**STAFF REPORT**  
**COMMUNITY DEVELOPMENT DEPARTMENT**

HEARING DATE: 9/6/2022  
TO: Mayor & City Council  
FROM: Sonya Allen, Associate Planner  
208-884-5533  
SUBJECT: FP-2022-0020; A-2022-0150  
Acclima Subdivision (aka Aviator Springs)  
LOCATION: 3235 N. McDermott Rd., in the SE 1/4 of Section 32, T.4N., R.1W.

B. Final Plat (dated: 5/31/22)

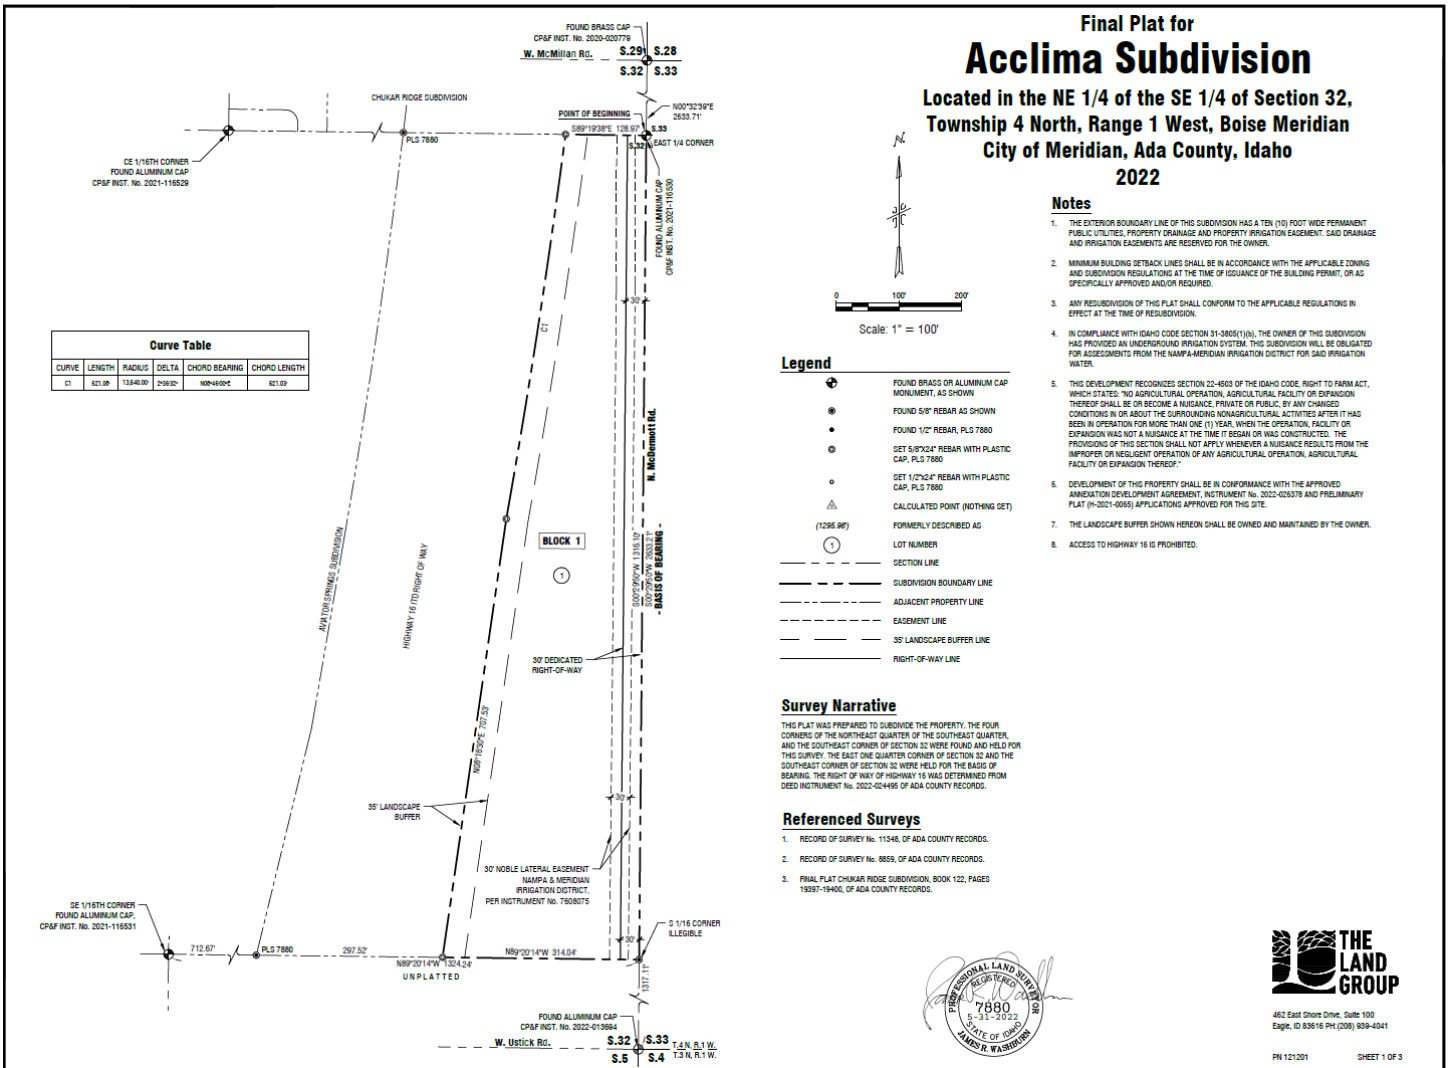
3. Prior to submittal for the City Engineer's signature, have the Certificate of Owners and the accompanying acknowledgement signed and notarized.
4. The final plat prepared by The Land Group, stamped by James R. Washburn, dated: 5/31/2022, included in Section V.B shall be revised as follows:

- a. Depict a minimum 35-foot wide street buffer along N. McDermott Rd., an entryway corridor, in a common lot or a permanent dedicated buffer in accord with UDC 11-3B-7C.2a.

- b. Modify plat note #7 as follows: "The landscape buffers shown hereon shall be ~~owned and~~ maintained by the property owner."

**L1.01**  
 Landscape Plan Area 1

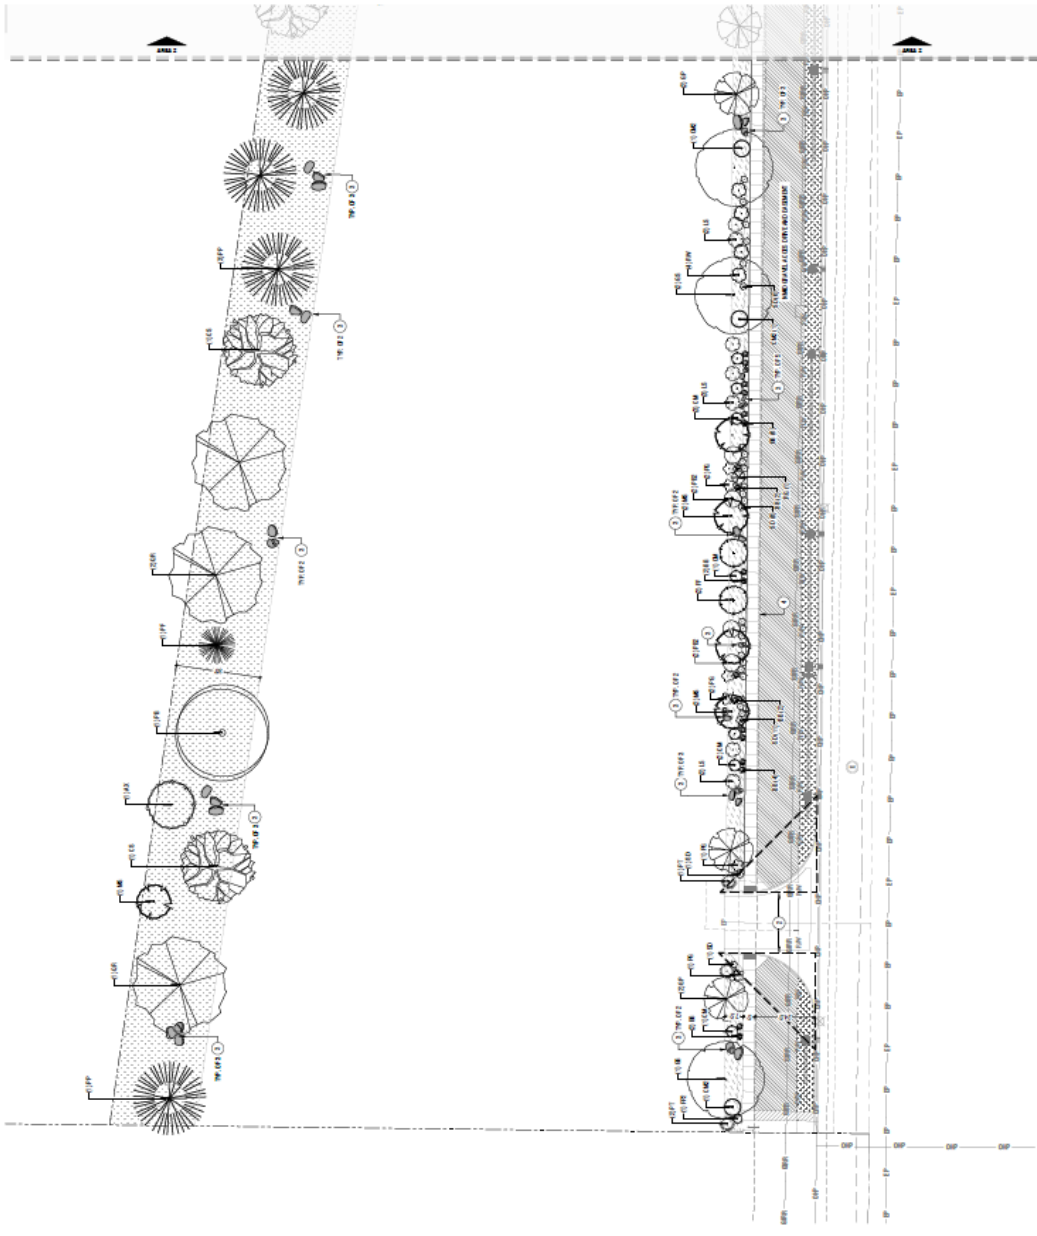
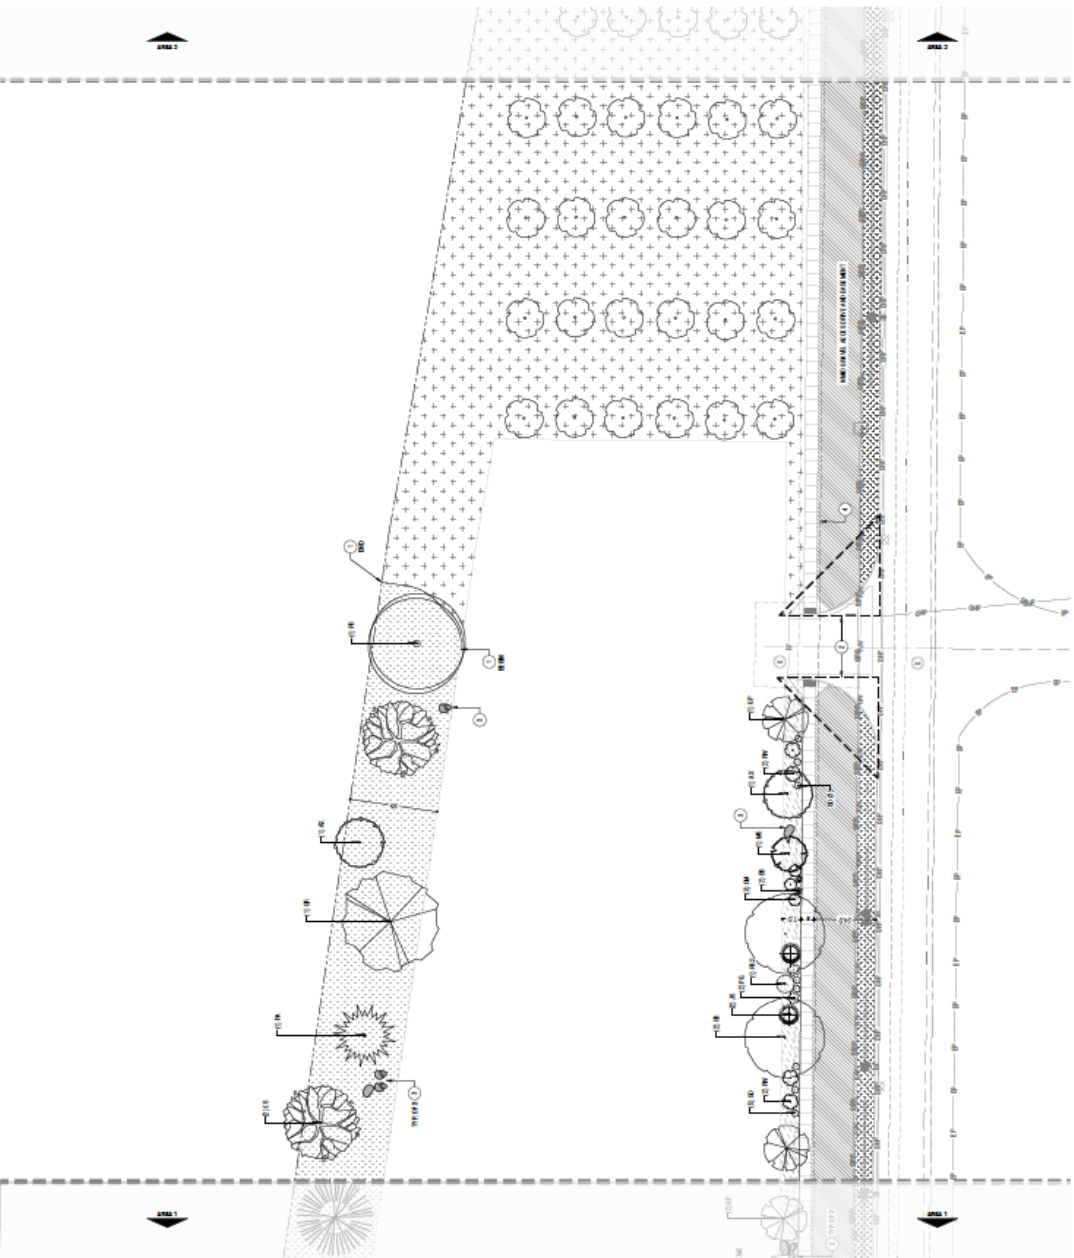
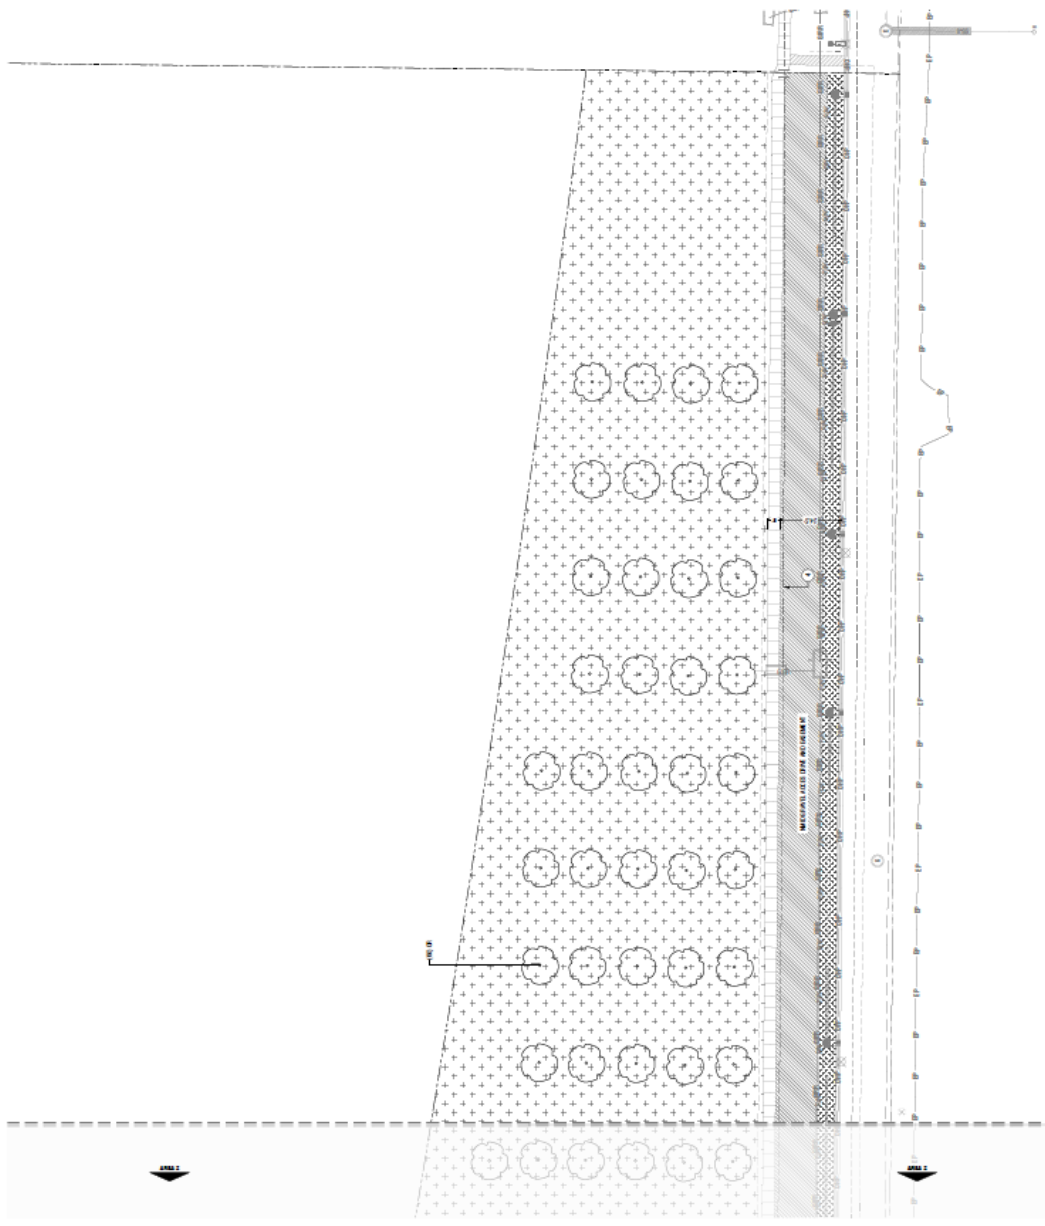
5. The landscape plan prepared by The Land Group, Inc., dated 7/12/2022, included in Section V.C, shall be revised as follows:
  - a. Depict shrubs and vegetative groundcover within the 35-foot wide street buffers along N. McDermott Rd. and future SH-16 in accord with the standards listed in UDC [11-3B-7C.3a](#). *Alternative compliance was approved to the standards in UDC 11-3B-7C.3b, which require trees within the street buffer, to allow an orchard in lieu of street trees on the northern 1/3 of the property within the street buffers along future SH-16 and N. McDermott Rd.*
  - b. Evenly disperse the trees in the orchard over the entire northern portion of the property. *The orchard trees are not required to be installed until the time of lot development.*
